STATE OF VERMONT
AGENCY OF TRANSPORTATION

PROPOSED IMPROVEMENT
BRIDGE PROJECT

TOWN OF RIPTON
COUNTY OF ADDISON

RECORD PLANS

REVISED ABUTMENT #2 PLAN
SCALE: 1:50

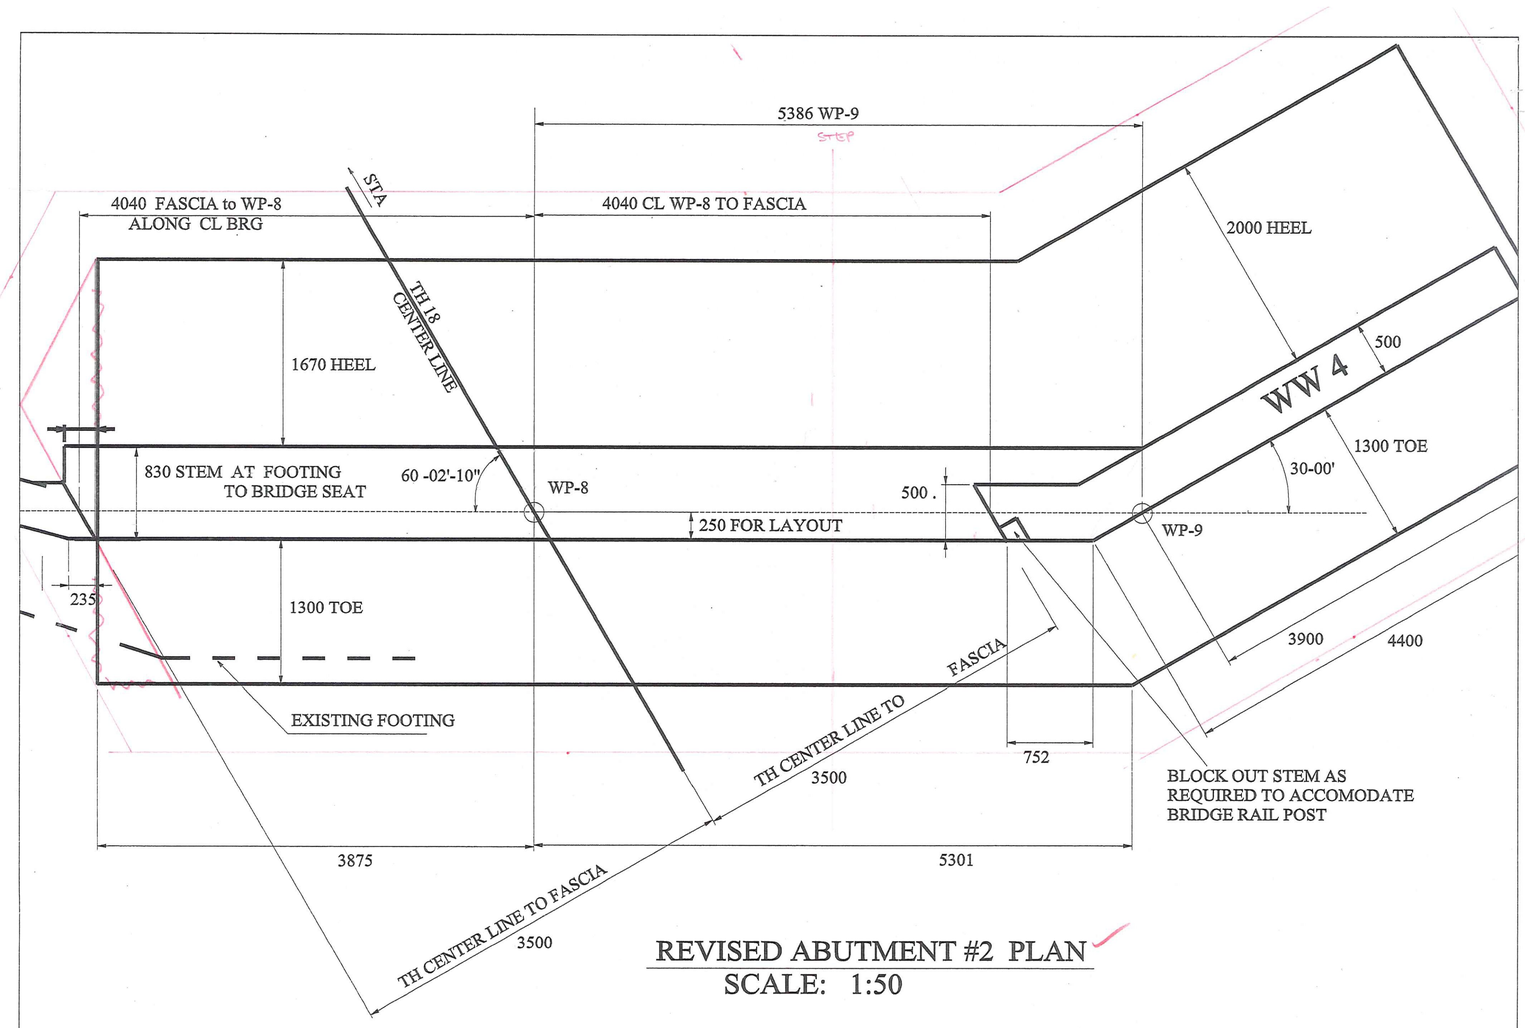
NOTES: 1. THE WORKING POINTS (WP) LAYOUT HAVE NOT CHANGED. WW #4 IS IN THE SAME LOACTION.
